# 1015 DAIRY DRIVE

## TSL DAIRY INC.

## CONTRACT NO. 142817

| No. | DESCRIPTION                      | DATE       |
|-----|----------------------------------|------------|
| 1   | SUBMISSION NO. 1 FOR CITY REVIEW | 2024-02-14 |

C-010

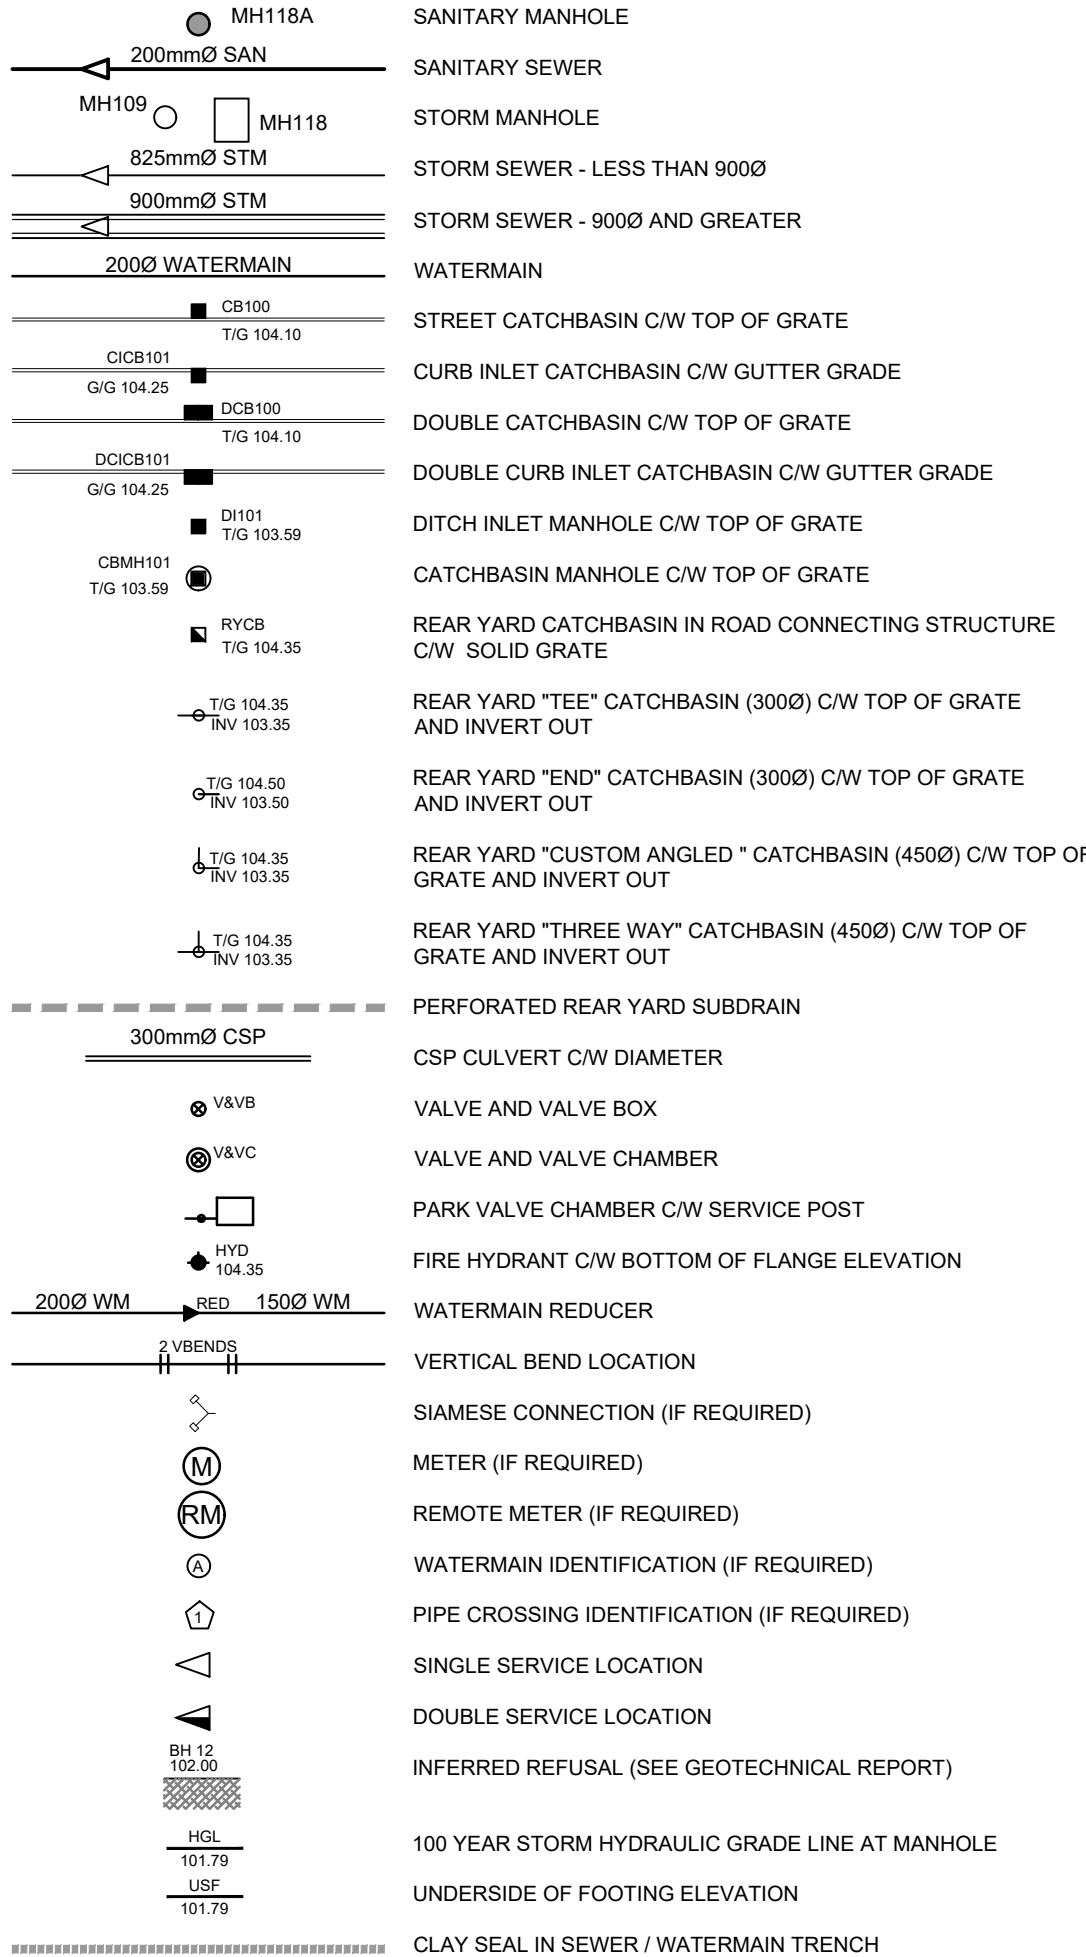
Provide notes for watermains crossing under/above sewers. City Spec W25 is to be followed for crossings under sewers, W25.2 is to be followed for crossings above sewers.

Covered under general note 1. 250mm provided for all sewer-sewer crossings, 250mm provided when water crossing over sewer and 500mm provided when sewer crossing over water.
